**State of West Virginia
 Solicitation Response**

Proc Folder : 414207
Solicitation Description : Addendum No. 2
Proc Type : Central Purchase Order

The West Virginia Purchasing Division is soliciting bids on behalf of the West Virginia State Rail Authority (SRA) to establish a contract for the following: Repairs to bridges along the South Branch Valley Railroad (SBVR) The Vendor shall furnish any incidental work, materials, labor, and equipment that are necessary to complete the Construction Services per the terms and conditions and specifications as attached.

**Addendum No. 2 – CRFQ RMA1800000007
Questions and Answers**

WEST VIRGINIA RAILROAD MAINTENANCE AUTHORITY
 SOUTH BRANCH VALLEY RAIL ROAD
 TRACK CHART - M.P. 30 TO M.P. 35
 PREPARED BY THEODORE BRADY & COMPANY, INC.
 ONE SATELITE CENTER, PITTSBURGH, PA. 15222
 SHEET NO. _____
 DATE _____

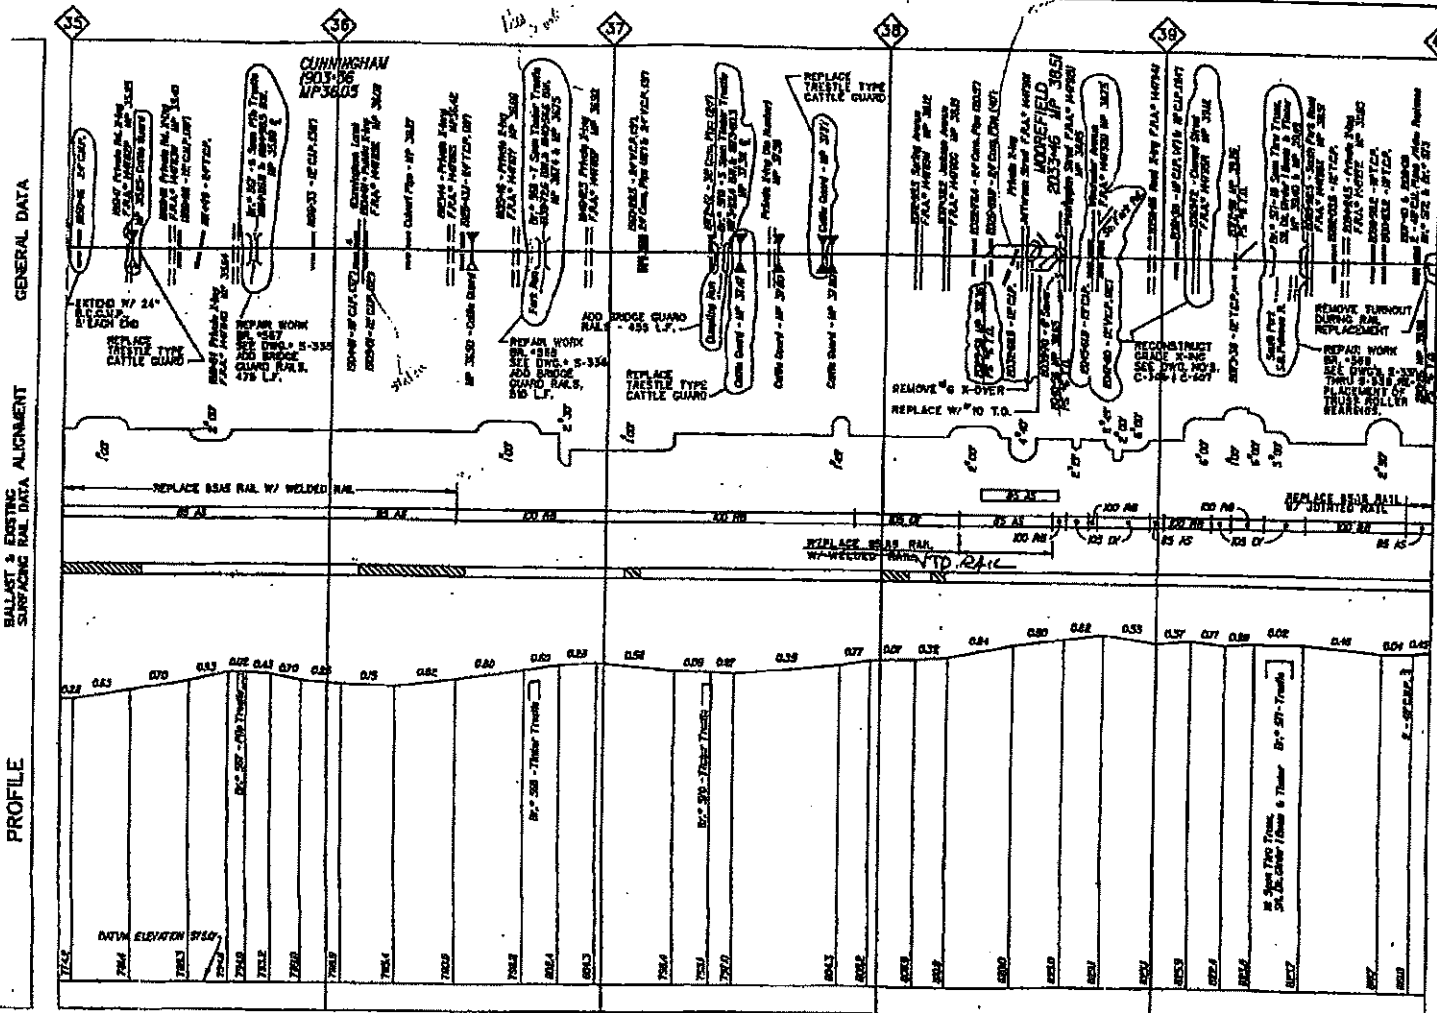
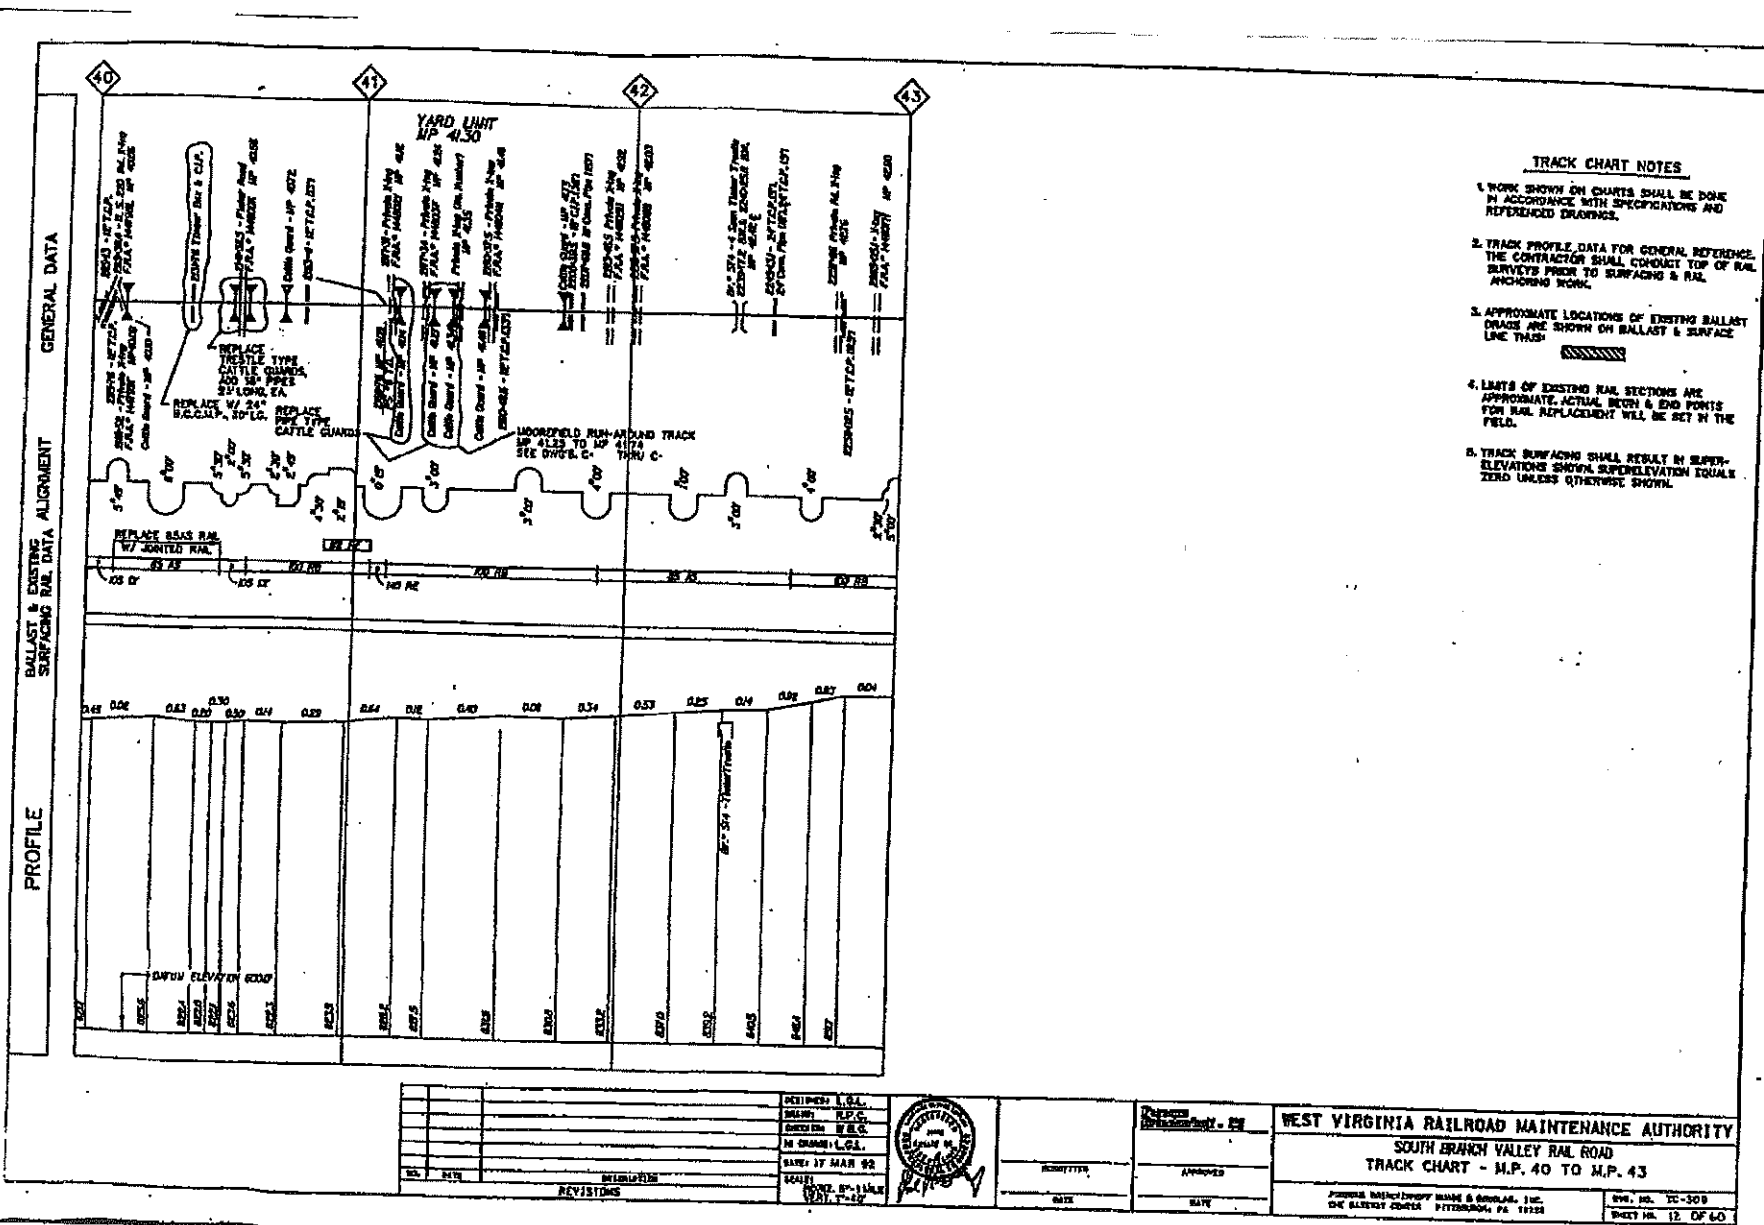
Q7. Can a copy of the track chart/profile extending 1 mile beyond each end of the milepost project limits be provided?

A7. Yes - Attached
